## **PROVISION POINT SUBDIVISION**

APPLICATION NUMBER 4 DATE June 7, 2012  
 APPLICANT Provision Point Subdivision  
 REQUEST Subdivision

# DETAIL SITE PLAN

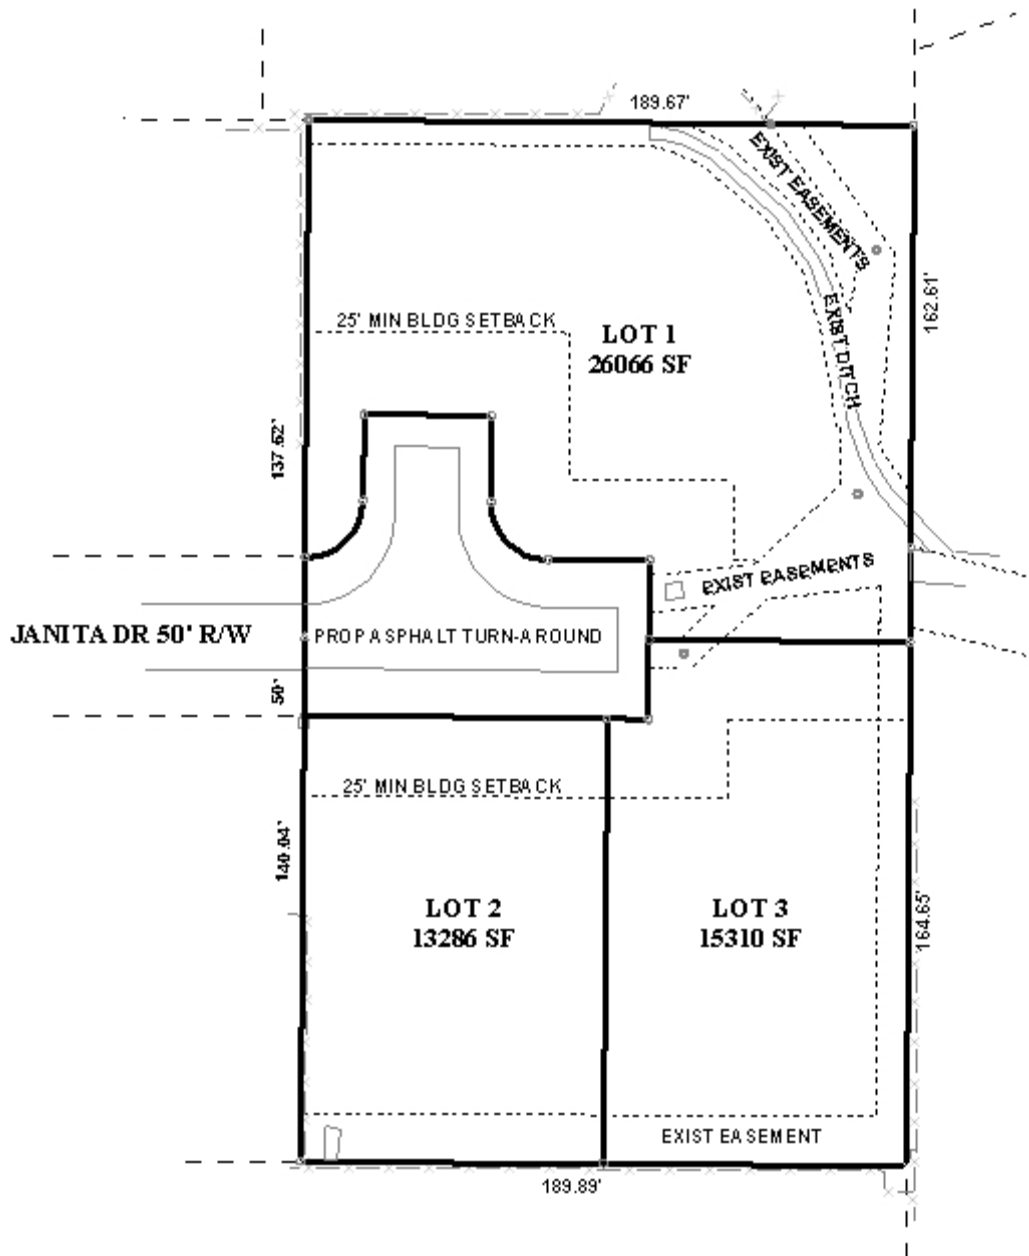
The plat illustrates the proposed 3 lot, 1.4 ± acre subdivision which is located at the East terminus of Janita Drive. The applicant states that the subdivision is served by public water and sanitary sewer systems.

The site was most recently approved as a one (1) lot subdivision with hammerhead turnaround by the Planning Commission at its December 15, 2011 meeting. The applicant now proposes 3 lots with a hammerhead turnaround: the two additional lots are, according to the applicant, intended to help defray the cost of constructing the required turnaround.

The site is located at the end of Janita Drive, which is a minor, closed-end street provided with curb and gutter, but not provided with a cul-de-sac or turnaround. Section V.B.6. of the Subdivision Regulations requires a turnaround to be provided at the end of a closed-end street. The applicant has requested that a hammer-head turn-around be allowed in lieu of a cul-de-sac turnaround, as approved by the Planning Commission at its December 2011 meeting.

Section V.B.14. of the Subdivision Regulations requires a 120-foot diameter cul-de-sac turnaround for a closed end street. The applicant states that this requirement would cause the proposed lot to be unbuildable. As such, the cul-de-sac requirement was waived by the Planning Commission at its December 2011 meeting, in lieu of the proposed hammerhead turnaround.

Each proposed lot appears to meet the minimum size and dimensional requirements of the Subdivision Regulations: lot sizes range from a minimum of 13,000 square feet to over 26,000 square feet, larger than many of the lots located to the West on Janita Drive.

There are multiple utility and drainage easements across the site. A note should be placed on the final plat stating that no habitable structure or in-ground swimming pool shall be placed within any drainage or utility easements.

Due to the development's location at the terminus of Janita Drive, access management is a concern. Each lot should be limited to one curb-cut, with the size, design and location to be approved by Mobile County Engineering, and conform with AASHTO standards.

The 25-foot minimum building setback is shown on the plat and should be retained on the final plat.

The lot size information on the preliminary plat should be retained for the final plat.

With a waiver of Section V.B.14. and V.B.15. of the Subdivision Regulations regarding right-of-way and roadway widths for closed-end street turnarounds, this application is recommended for tentative approval subject to the following conditions:

- 1) construction and dedication of the hammerhead turnaround and associated right-of-way at the terminus of Janita Drive as depicted;
- 2) retention of the 25-foot minimum building setback line around the hammerhead turnaround as depicted;

- 3) retention of the lot area size, in square feet, exclusive of any area dedicated for the required turnaround;
- 4) placement of a note on the Final Plat limiting each lot to one curb cut to Janita Drive with the size, design and location to be approved by Mobile County Engineering and conform to AASHTO standards;

- 5) placement of a note on the Final Plat stating that no habitable structure or in-ground swimming pool shall be placed within any drainage or utility easements;
